DRB-97-386

SITE PLAN AMENDMENT DRB-97-386  
 E.P.C. CASE NO. 2-77-178

THE SUMMIT APARTMENTS  
 5401 N. HIGH SCHOOL BLVD. S.W.

**SUMMIT OFFICE BUILDING  
PARKING IMPROVEMENTS  
ALBUQUERQUE, NEW MEXICO  
GRADING & DRAINAGE PLAN**

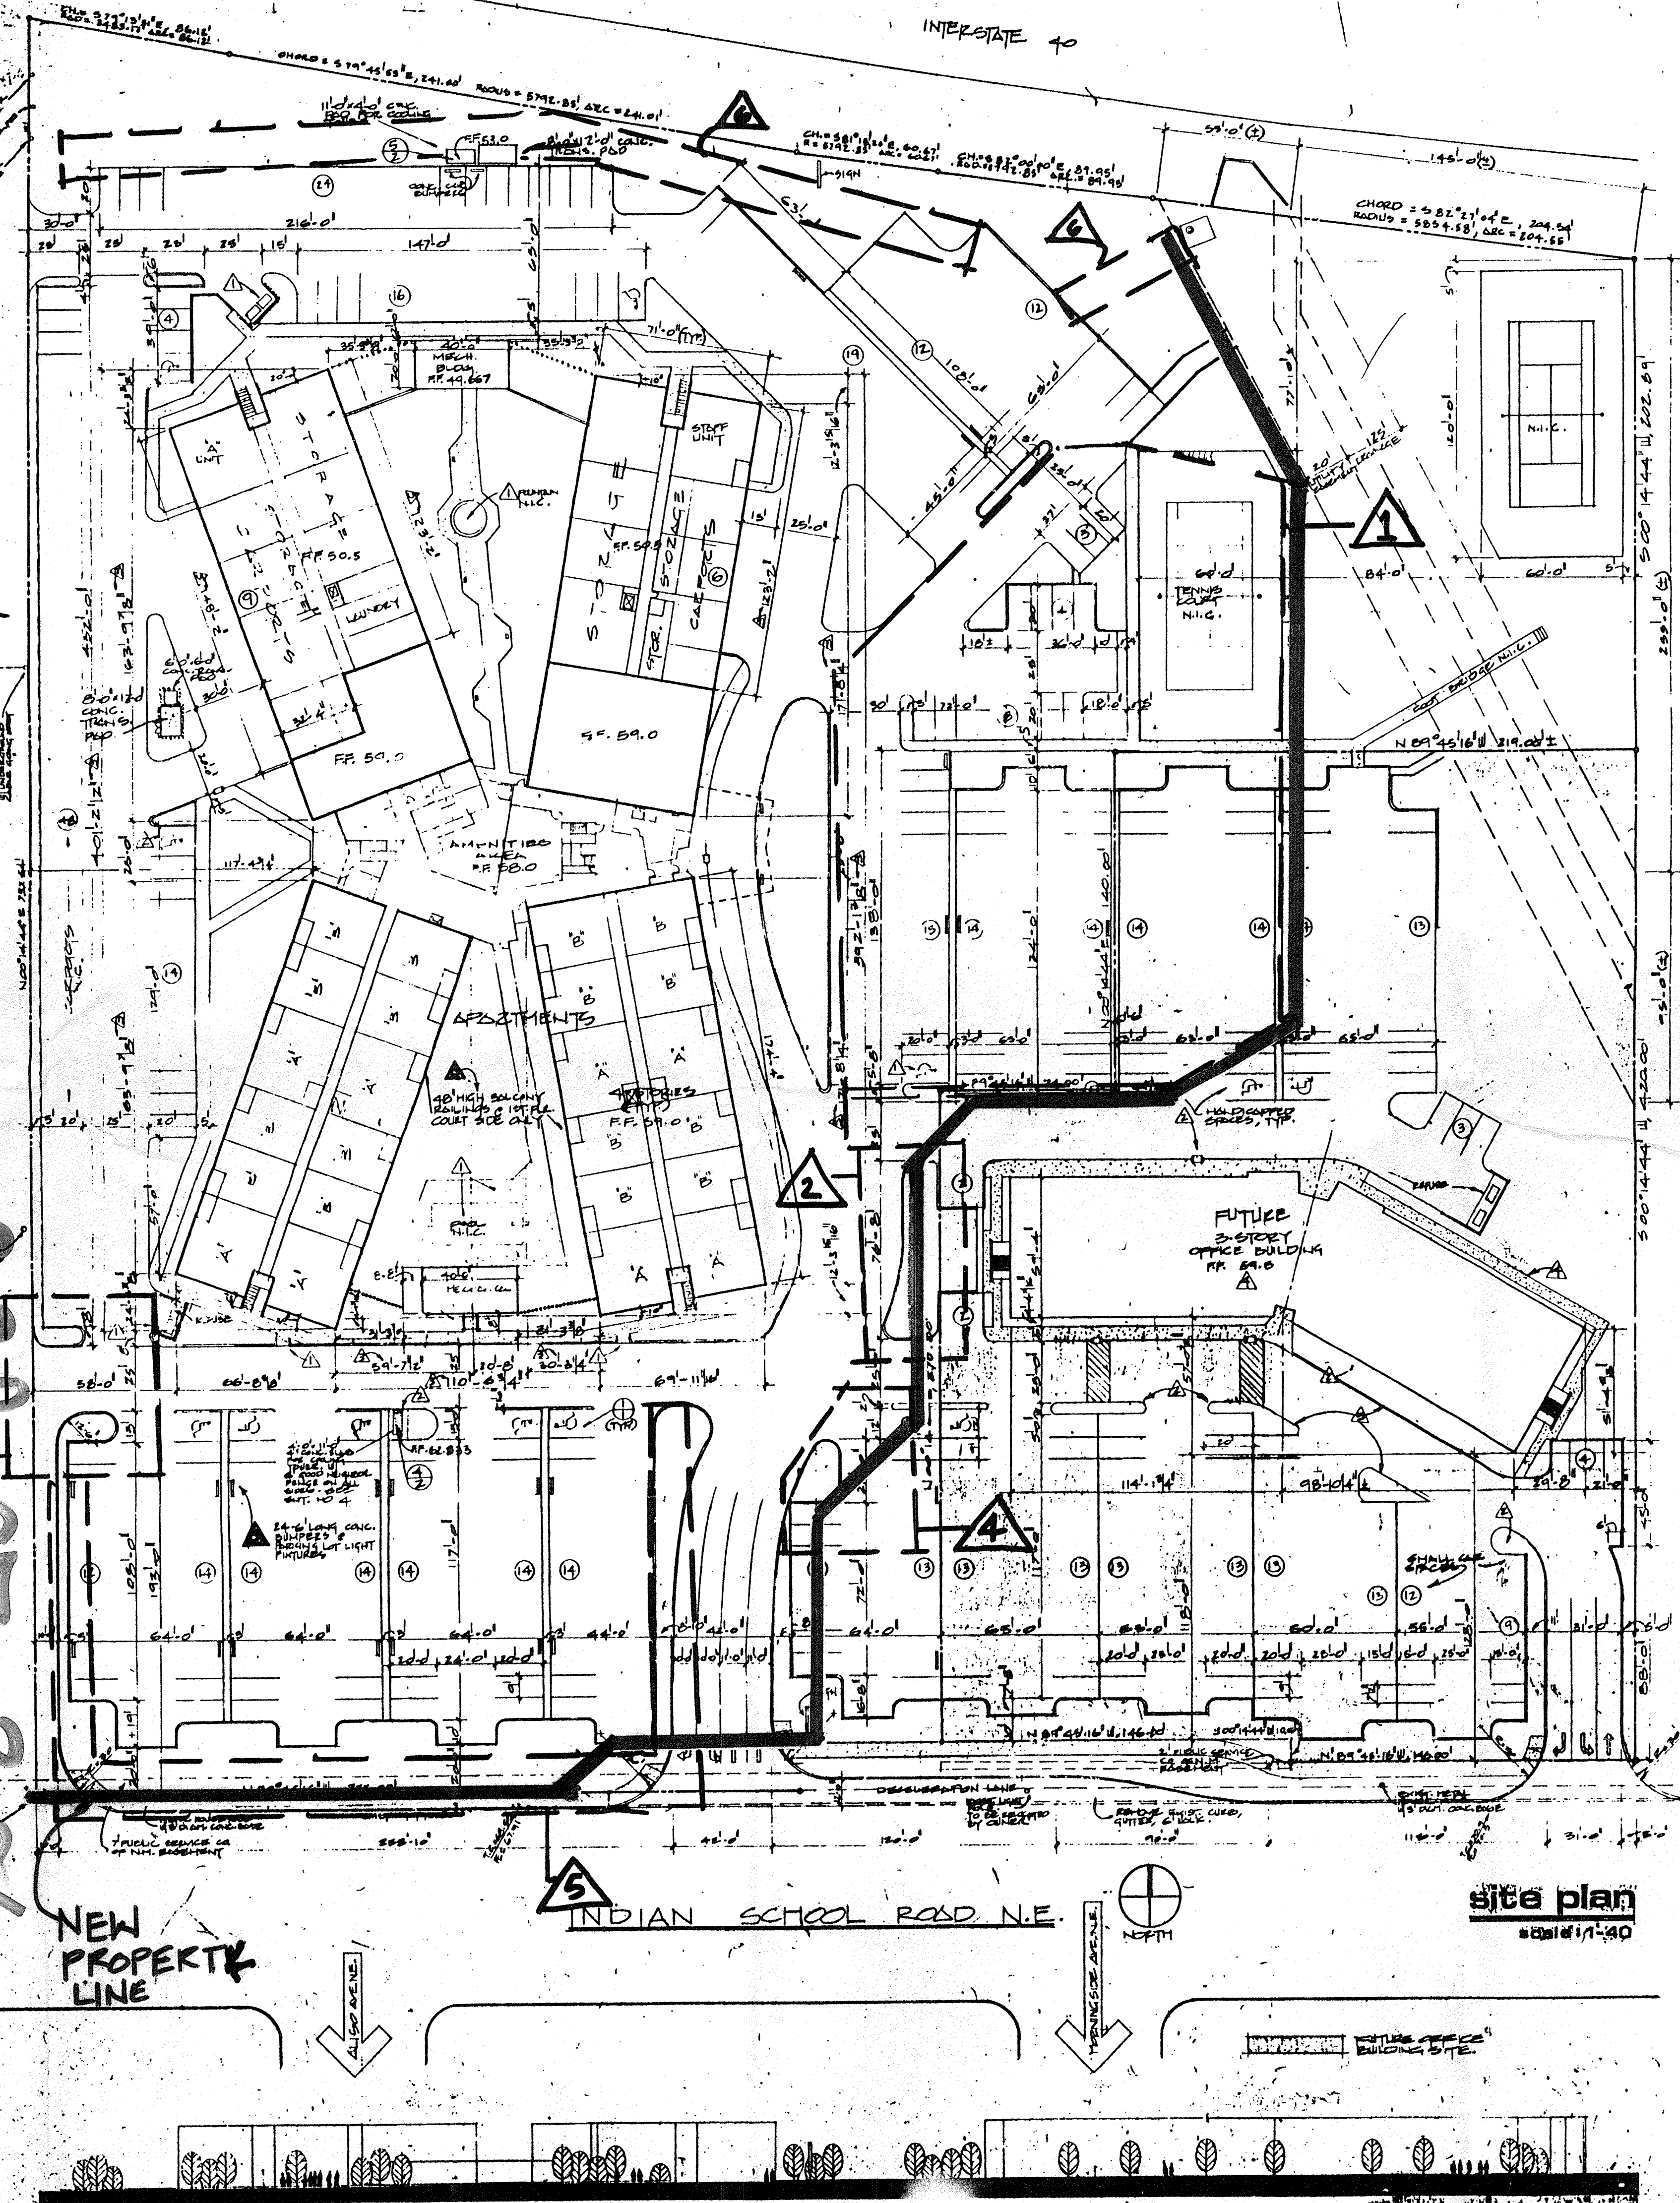
FOR HYDROLOGY APPROVAL:  
APP'D FOR SITE PLAN & PAVING  
PERMIT CONDITIONAL UPON  
"AS-BUILT" REFLECTING  
SPOT ELEVATIONS FOR  
ENTIRE SITE  
(CERTIFICATION FOR DPM)

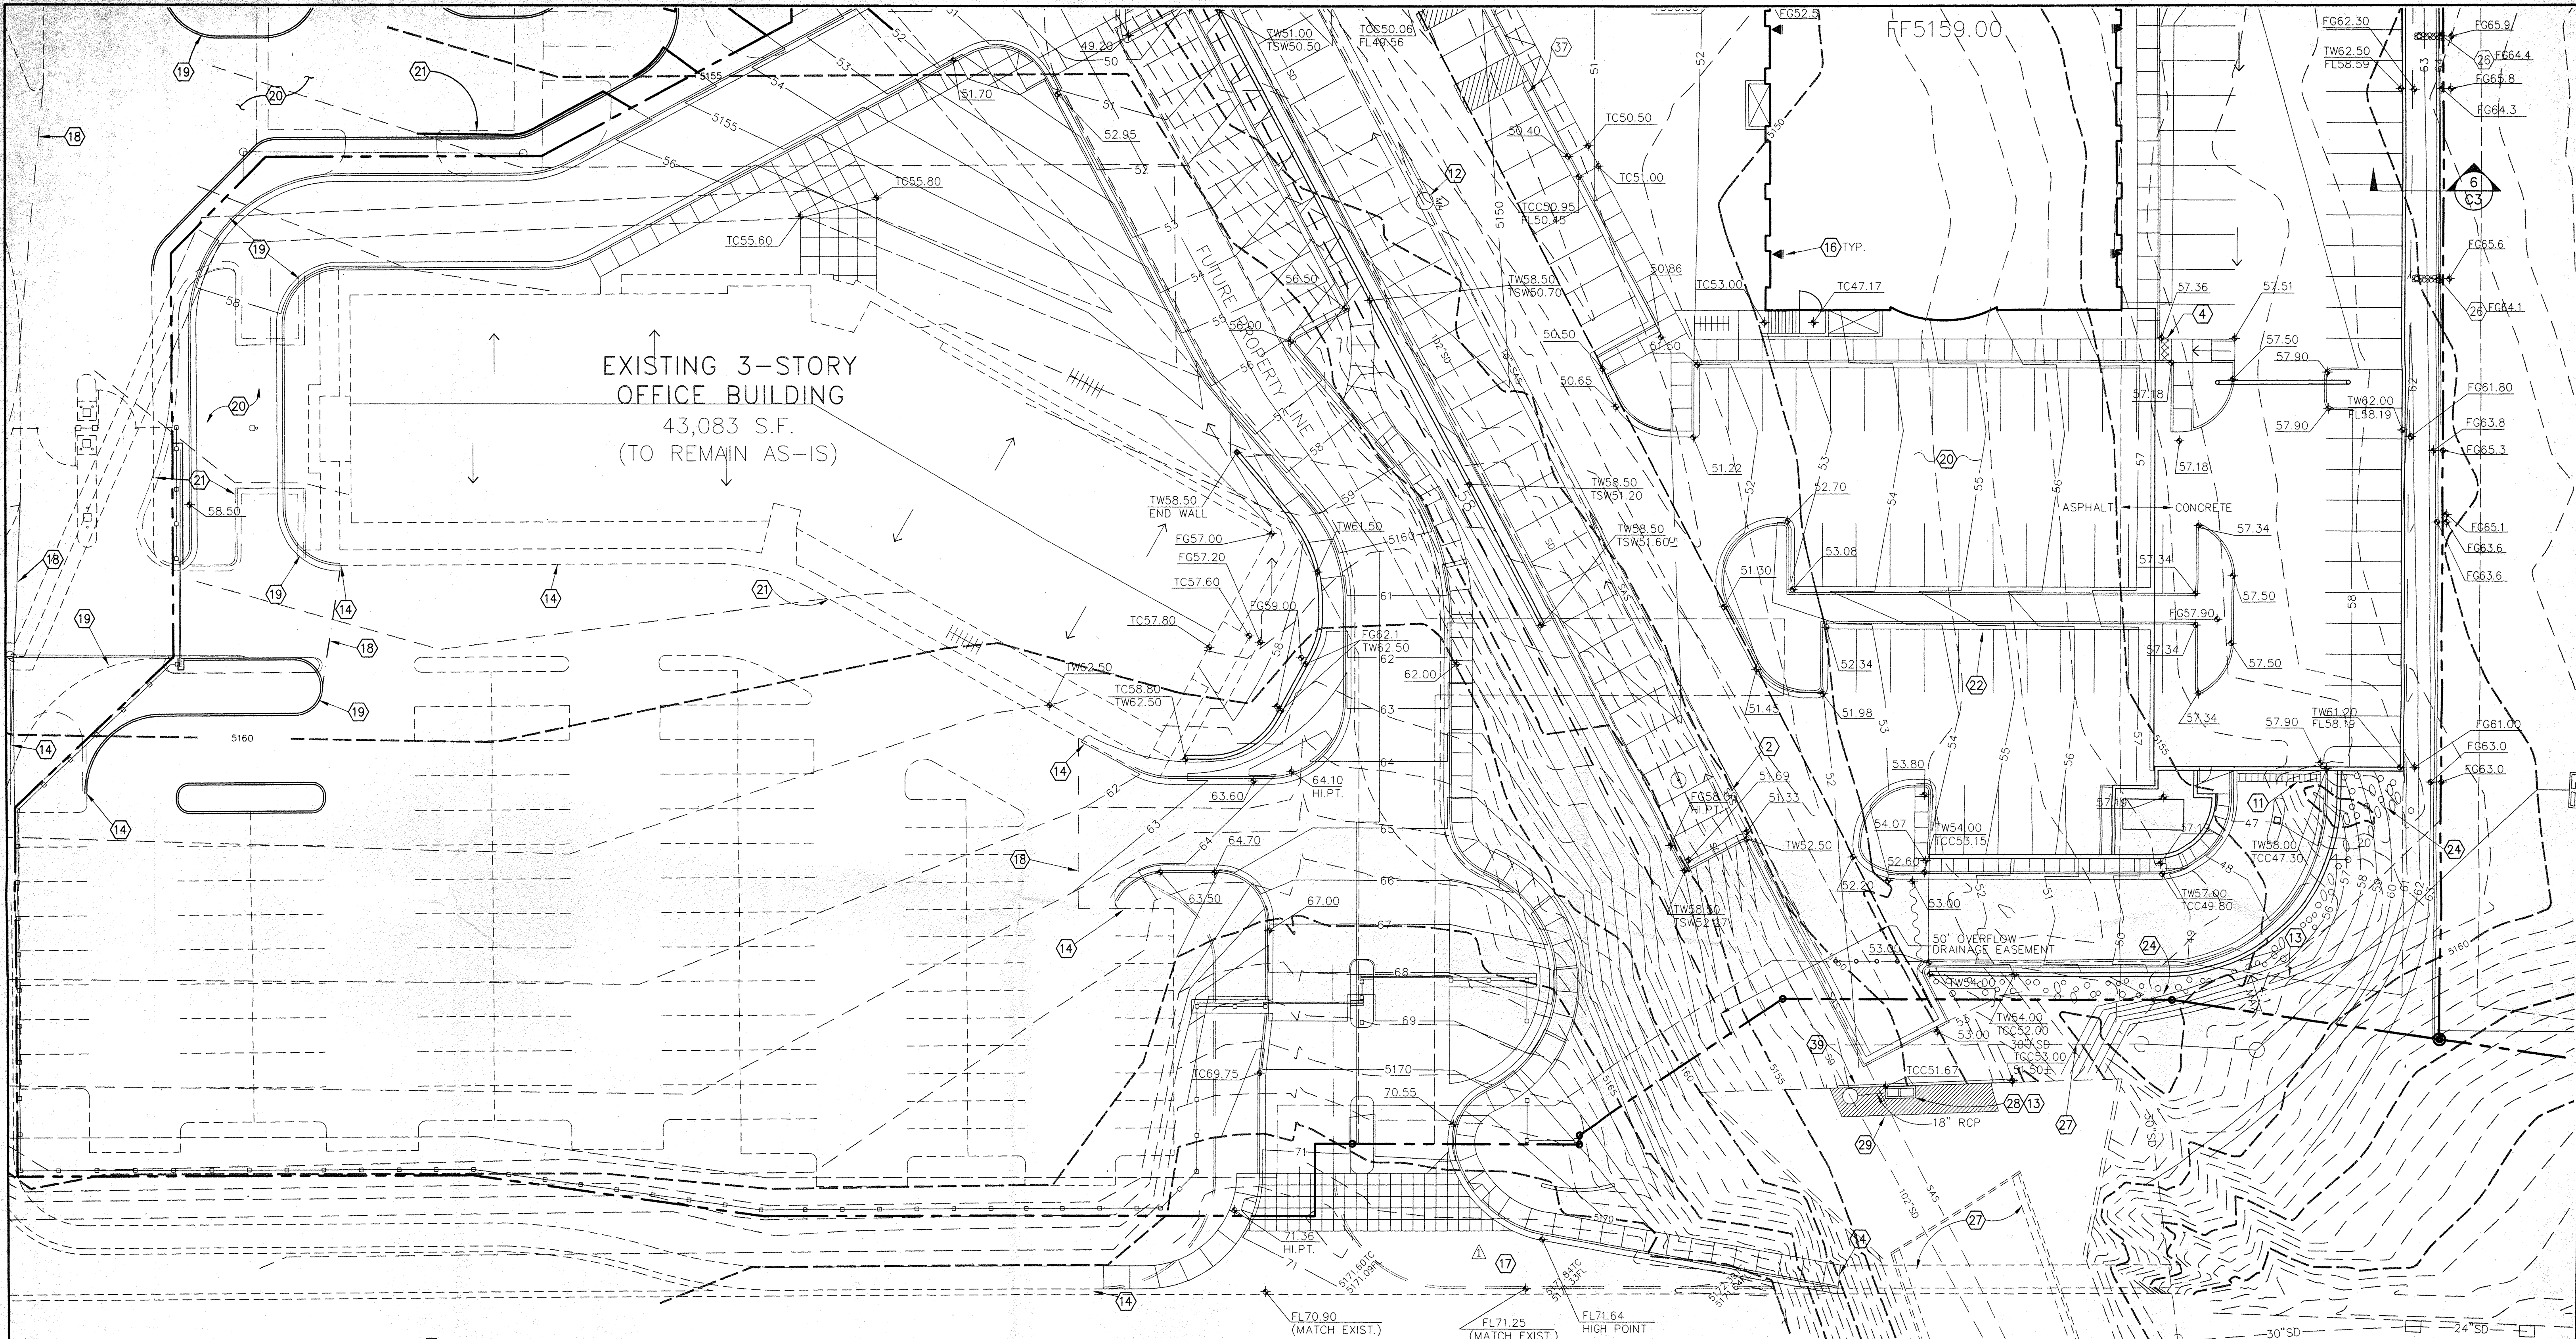
- ### DRB-97-386 AMENDMENT TO APPR.
- △ DUE TO PROPERTY LINE CHANGES THE TENNIS COURT WILL BE REMOVED AND THE PARKING LOT WILL BE RECONFIGURED.
  - △ THE ENTRANCE TO THE SUMMIT APARTMENT WILL BE NARROWED TO A MINIMUM WIDTH OF 24' TO ALLOW FOR A FULL WIDTH ELECTRIC SLIDING GATE. THE GATE WILL BE OPENED DURING BUSINESS HOURS.

- △ VEHICULAR ACCESS TO K-MART WILL BE TERMINATED TO SECURE THE SITE. A LANDSCAPED AREA WITH A PEDESTRIAN GATE WILL BE PROVIDED.
  - △ DUE TO PROPERTY LINE CHANGES THE CONCRETE CURBING WILL BE RECONFIGURED.

- △ ADD PERMANENT FENCING AT WEST AND SOUTH END OF SITE. FENCING NOT ABSTRACT SITE.
  - △ ADD 12' NOISE WALL TO NORTH SIDE OF LOT.
  - △ 7-9-79 CHANGES MAKE PER APPENDUM NO. 4
